LAND USE APPLICATION - COMPLETENESS REVIEW

Subject Property:	676 17 th Street SE
Reference Number:	24-103565-PLN
Application Type:	Class 3 Site Plan Review and Class 1 Design Review
Date Application Accepted:	February 7, 2024
Applicant:	Servando Garcia S & V Garcia Investments LLC PO Box 21444 8135 River Road NE Keizer, OR 97307-1444 estimating@sunsetstuccolc.com
Contact:	Ronald Ped 6850 Burnett Street SE Salem, OR 97317 rjp@rktect.com

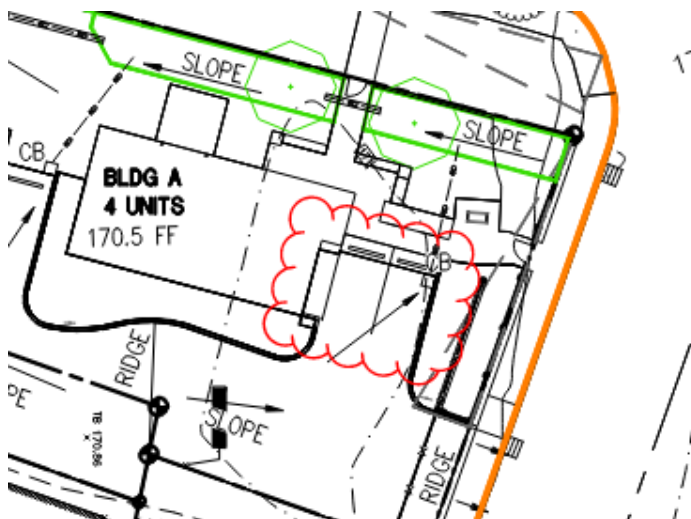
702.015(b)(1) – Landscaping Standards	Where a development site abuts property that is zoned RS (Single Family Residential), a combination of landscaping and screening shall be provided to buffer between the multi-family residential development and abutting RS zoned property.

Not addressed. See included plan markup.

Screening includes: a minimum of one tree for every 30 linear feet of abutting property width and a minimum six foot tall, decorative, sight obscuring fence or wall.

No screening is proposed along the eastern property line where the subject property abuts RS zoned property. Please revise the site plan to demonstrate compliance with the standard.

Adjustment was previously requested. A revised adjustment letter has been submitted with this response,

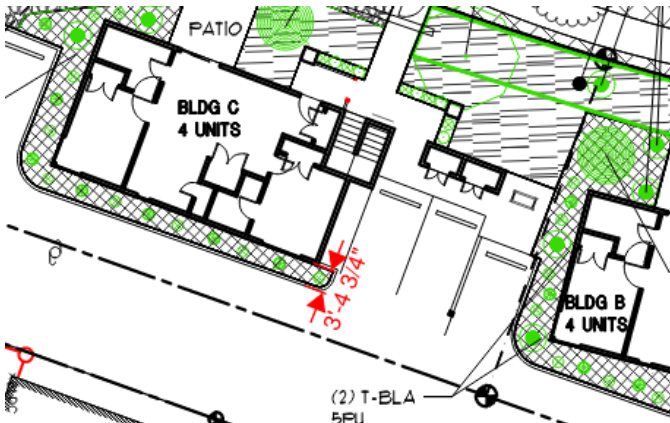
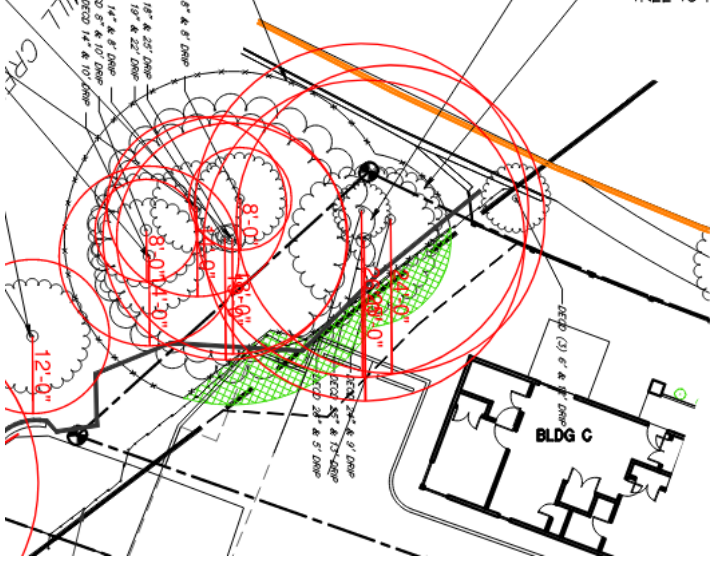
702.015(d)(1) – Parking and Site Design Standards
Not addressed.
Proposed configuration does not comply, an Adjustment to this standard will not be supported.

See included plan markup.

To minimize the visual impact of on-site parking and to enhance the pedestrian experience, off-street surface parking areas and vehicle maneuvering areas shall be located behind or beside buildings and structures. Off-street surface parking areas and vehicle maneuvering areas shall not be located between a building or structure and a street.

Off-street parking spaces are proposed between the ground level of the northern most building and Oak Street SE. Please adjust the orientation of the building and parking so parking spaces are not proposed between the ground floor and abutting street.

Parking spaces are provided on the under the upper floors of the building, however there is no

screening wall provided to obstruct view of the parking area.	
702.015(d)(2) – Parking and Site Design Standards Okay	<p>To ensure safe pedestrian access to and throughout a development site, pedestrian pathways shall be provided that connect to and between buildings, common open space, and parking areas, and that connect the development to the public sidewalks. Pedestrian pathways shall be a minimum of five feet in width.</p> <p>A pedestrian pathway connection to the southern most parking spaces and solid waste service area is required.</p>	
Chapter 800 – General Development Standards

Screening Wall added.
